DWN C.LACHALL	DATE 96/12/09	PROD ASSUR J.L. L	DATE 97-01-09	BOEING HELICOPTERS DCN		DWG NO. 145G0221	
CHK S.BRUNO	WT 96/12/17	WT		DRAWING CHANGE NOTICE 77272	SH 1 OF 5	REV C	DWG SH -
ENGR M. Junch Jr	97/01/09	MAT'L & PROC		REASON REVISED WELDMENT TO AID IN SETUP & ALIGNMENT WHEN USED IN THE 145G0294 FIXTURE	MODEL/ITEM NO. CH-47D,414-100 / 26300		
STRUCT		ORG D.Gallagher	97/01/09	CODE D.IMP	CHANGE NO. PRRSS000E		
PROJ J. Lachall	97-01-20	CUST Hill Corp	97/03/00	ORIGIN GSE 1459	CLASS PER MIL-STD-480 <input type="checkbox"/> CLASS I <input checked="" type="checkbox"/> CLASS II	SPARES AFFECTED <input type="checkbox"/> YES <input checked="" type="checkbox"/> NO	97/02/06 S.GRN
PL SH/ZONE	REPLACES QTY REQ'D	CODE IDENT	PART OR IDENTIFYING NO.	NOMENCLATURE OR DESCRIPTION	ZONE	MATERIAL AND SPECIFICATION	HT TR FINISH PT MK

ENGINEERING DRAWING CHANGE CONTINUATION SHEET

ORIG
DWG. NO.
145G0221

-406 WELDMENT ASSY

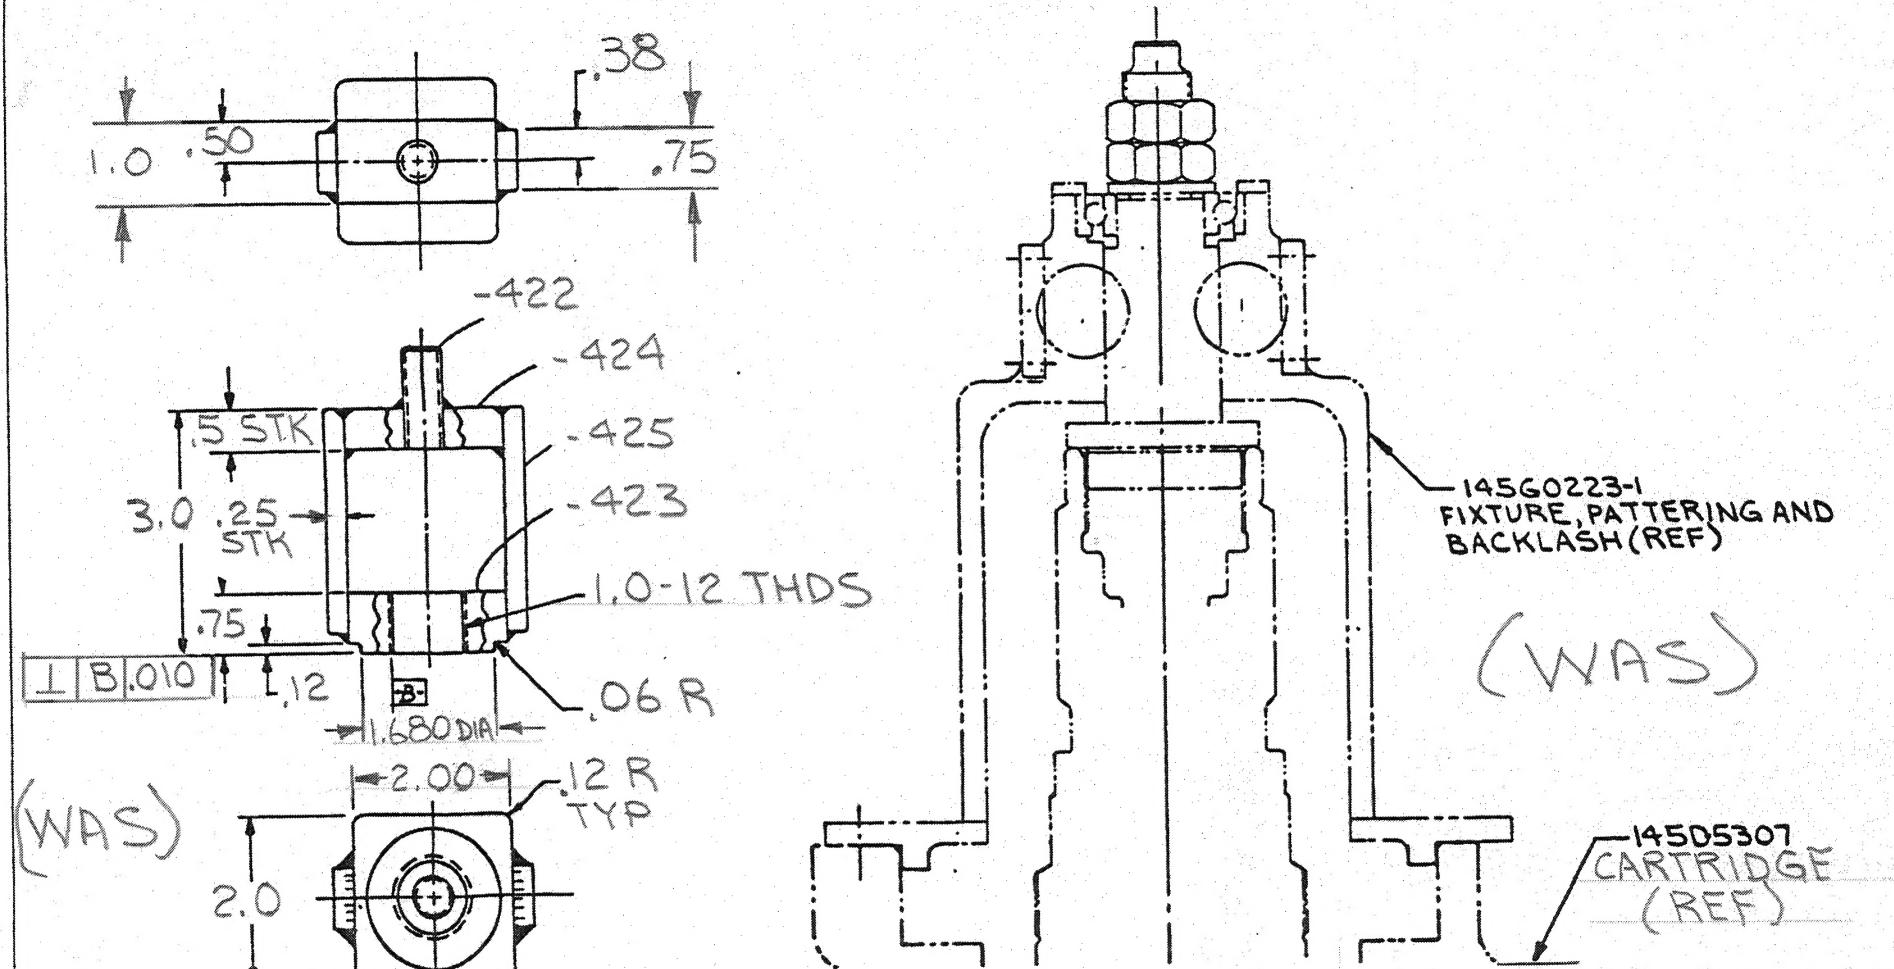
ZONE C6, REVISED - 406

ZONE D6, REVISED VIEW OF 145G0223-1
PATTERNING AND BACKLASH FIXTURE

-403 TAPERLOCK BUSH. ASSY

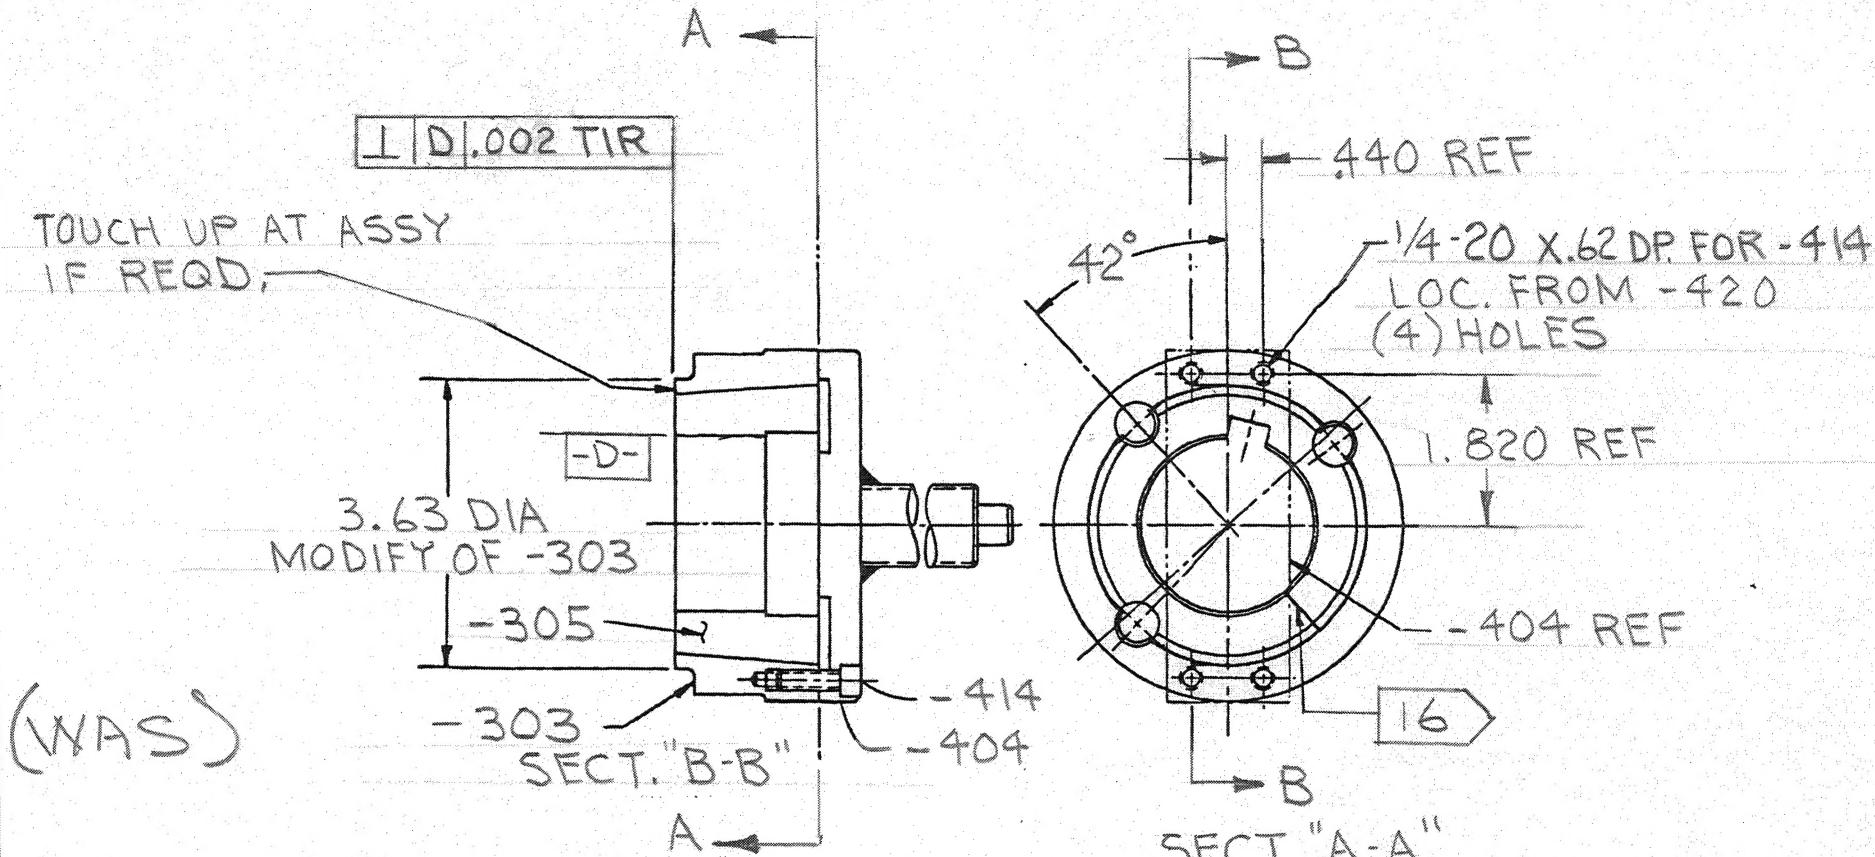
ZONE D4, REVISED -403 TAPERLOCK BUSH. ASSY
